Mobile Intel® Pentium® 4 Processor-M

Specification Update

December 2006

Document Number: 250721-037

Figure 13. System Bus Reset and Configuration Timings

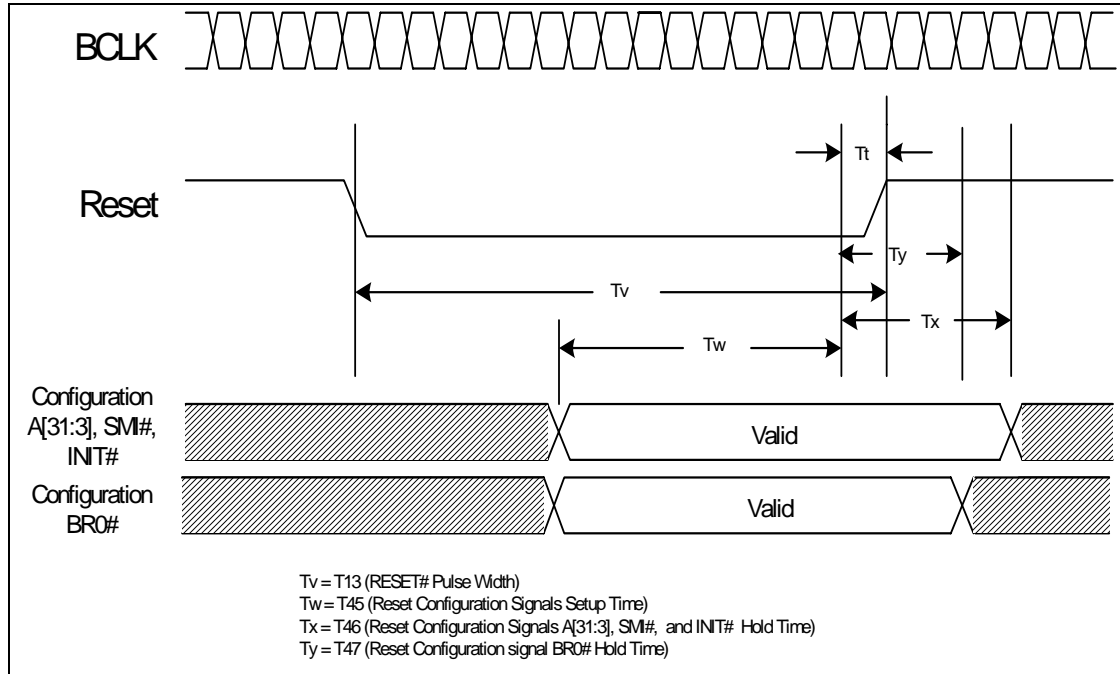
T2. BR0# Maximum Hold Time Specification Change

The BR0# maximum hold time has changed to 2 BCLKs. This change will be shown in the “System Bus AC Specifications (Reset Conditions)” table and “System Bus Reset and Configuration Timings” figure of the *Mobile Intel® Pentium® 4 Processor - M Datasheet*. This change will be incorporated in the next revision of the datasheet.

The following figure will be modified to reflect this change:
